ADDENDUM NO. 1

DATE: November 9, 2023

FROM: Baxter & Woodman, Inc., Consulting Engineers

City of Joliet, Illinois
West Park Water Main Improvements
City of Joliet Contract No. 2768-0124

BELLEVIEW AVENUE STA. 90+00 TO STA. 95+00 PLAN AND PROFILE

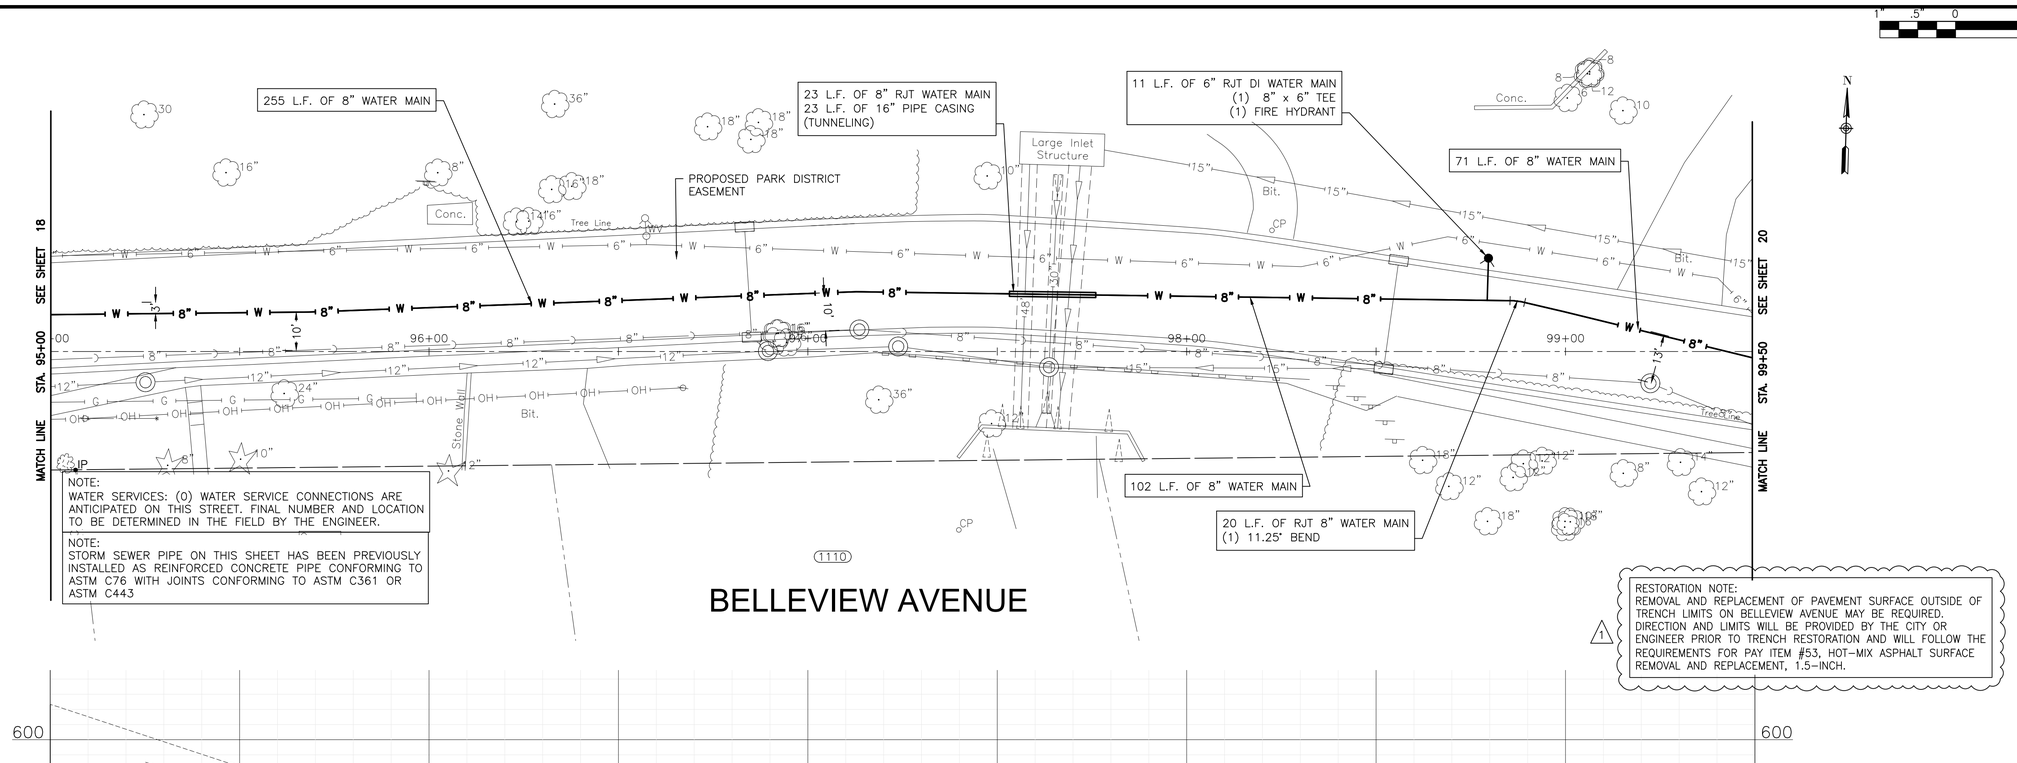
C. Delete Sheet 18 in its entirety and insert the attached Sheet 18, revision dated November 9, 2023, in lieu thereof in order to insert new Restoration Note.

1 RESTORATION NOTE:
REMOVAL AND REPLACEMENT OF PAVEMENT SURFACE OUTSIDE OF TRENCH LIMITS ON BELLEVIEW AVENUE MAY BE REQUIRED. DIRECTION AND LIMITS WILL BE PROVIDED BY THE CITY OR ENGINEER PRIOR TO TRENCH RESTORATION AND WILL FOLLOW THE REQUIREMENTS FOR PAY ITEM #53, HOT-MIX ASPHALT SURFACE REMOVAL AND REPLACEMENT, 1.5-INCH.

BELLEVIEW AVENUE STA. 95+00 TO STA. 99+50 PLAN AND PROFILE

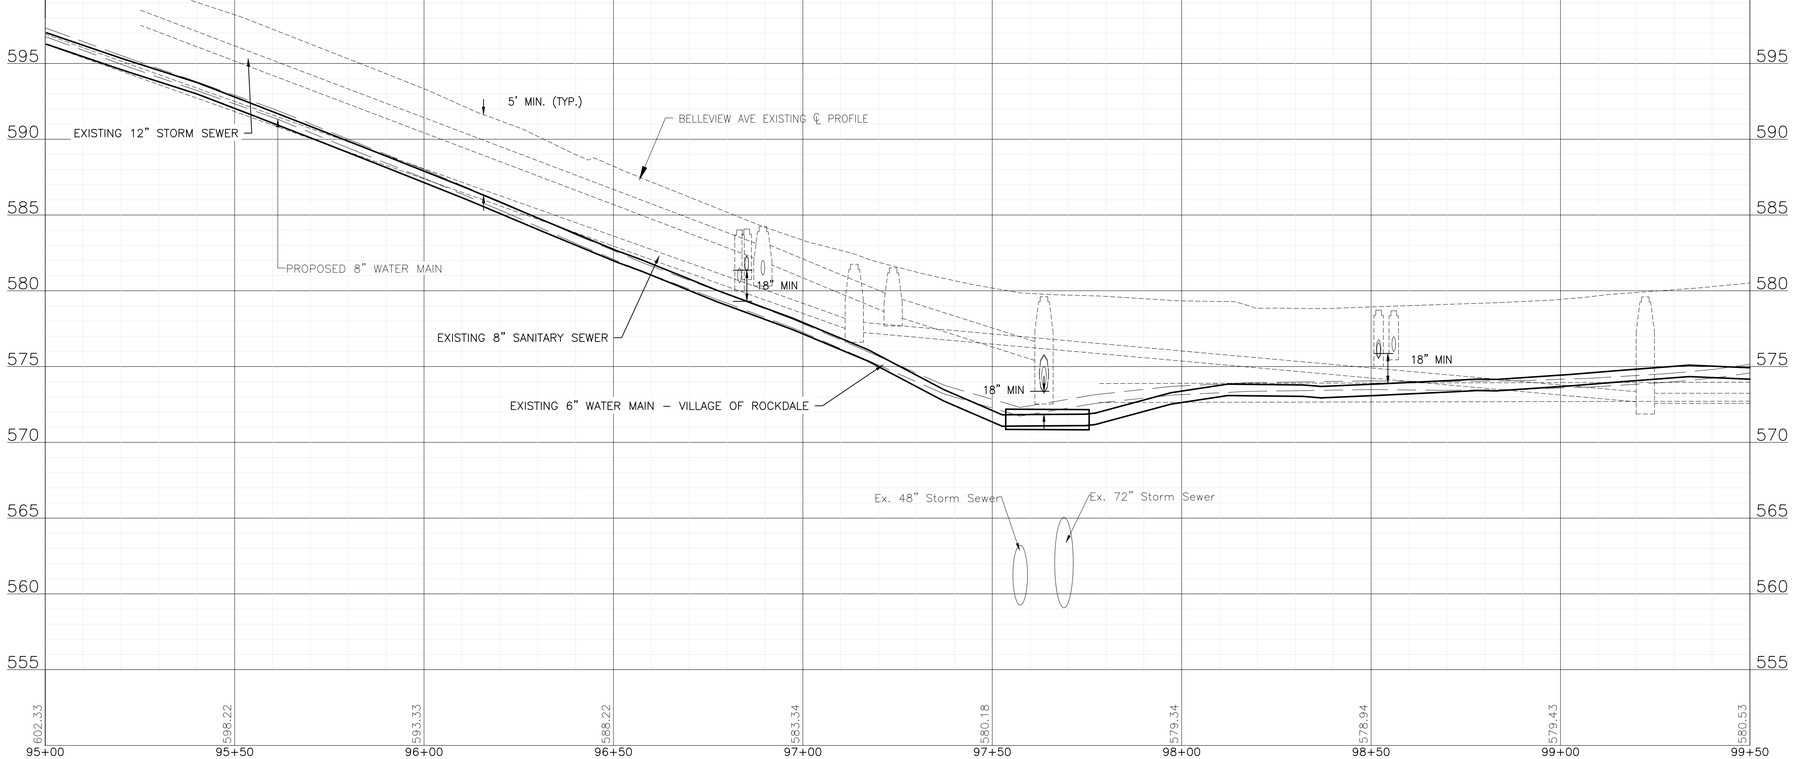
D. Delete Sheet 19 in its entirety and insert the attached Sheet 19, revision dated November 9, 2023, in lieu thereof in order to insert new Restoration Note

1 RESTORATION NOTE:
REMOVAL AND REPLACEMENT OF PAVEMENT SURFACE OUTSIDE OF TRENCH LIMITS ON BELLEVIEW AVENUE MAY BE REQUIRED. DIRECTION AND LIMITS WILL BE PROVIDED BY THE CITY OR ENGINEER PRIOR TO TRENCH RESTORATION AND WILL FOLLOW THE REQUIREMENTS FOR PAY ITEM #53, HOT-MIX ASPHALT SURFACE REMOVAL AND REPLACEMENT, 1.5-INCH.

BELLEVIEW AVENUE STA. 99+50 TO STA. 104+50 PLAN AND PROFILE

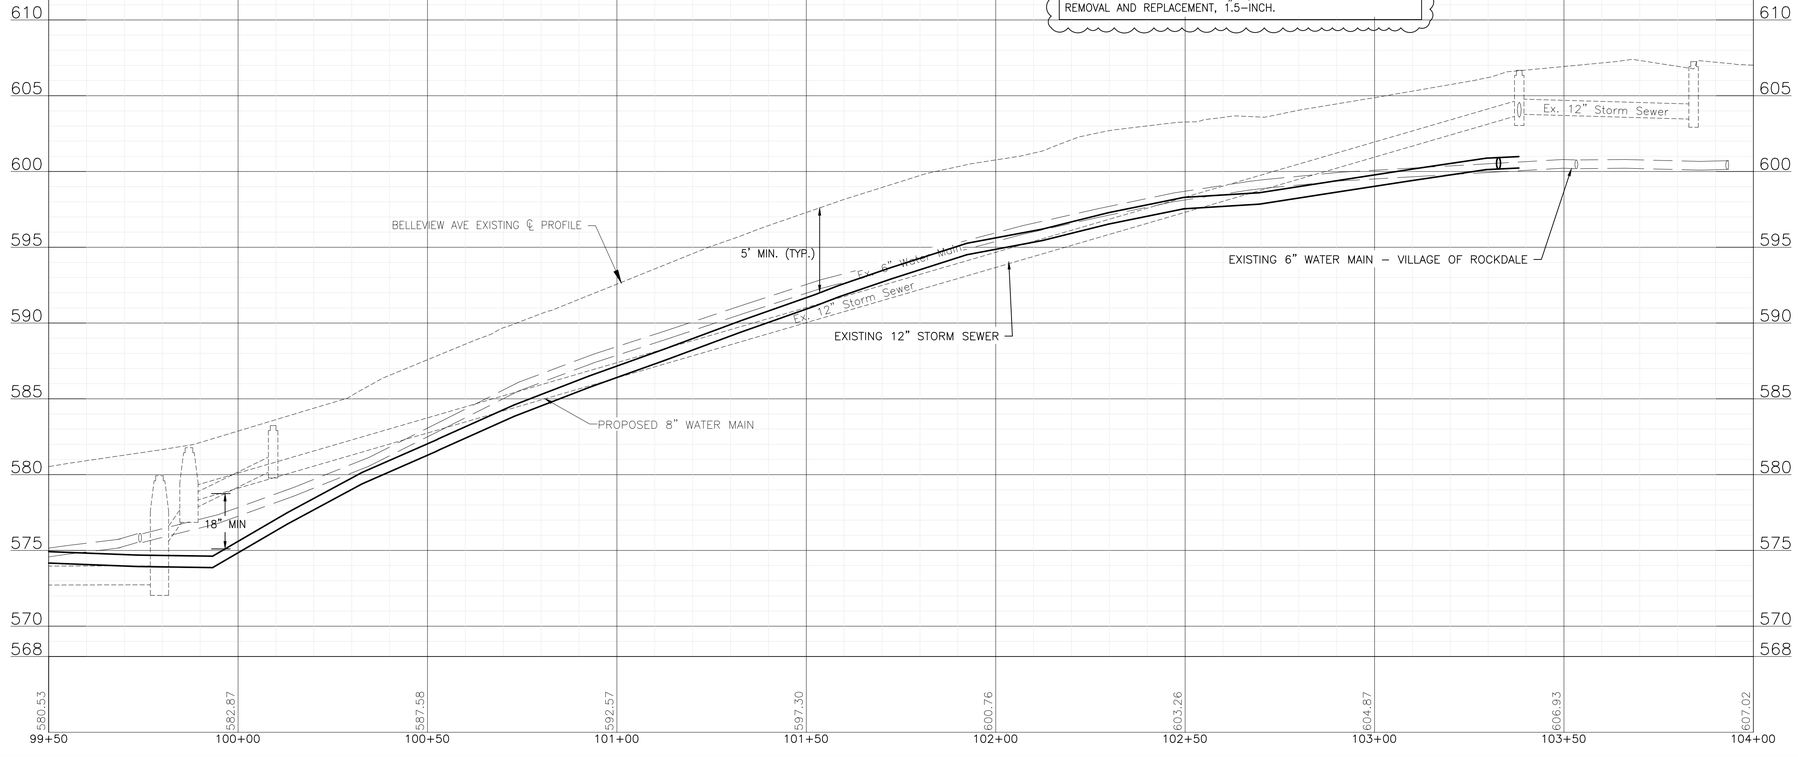
E. Delete Sheet 20 in its entirety and insert the attached Sheet 20, revision dated November 9, 2023, in lieu thereof in order to insert new Restoration Note.

1 RESTORATION NOTE:
REMOVAL AND REPLACEMENT OF PAVEMENT SURFACE OUTSIDE OF TRENCH LIMITS ON BELLEVIEW AVENUE MAY BE REQUIRED. DIRECTION AND LIMITS WILL BE PROVIDED BY THE CITY OR ENGINEER PRIOR TO TRENCH RESTORATION AND WILL FOLLOW THE REQUIREMENTS FOR PAY ITEM #53, HOT-MIX ASPHALT SURFACE REMOVAL AND REPLACEMENT, 1.5-INCH.
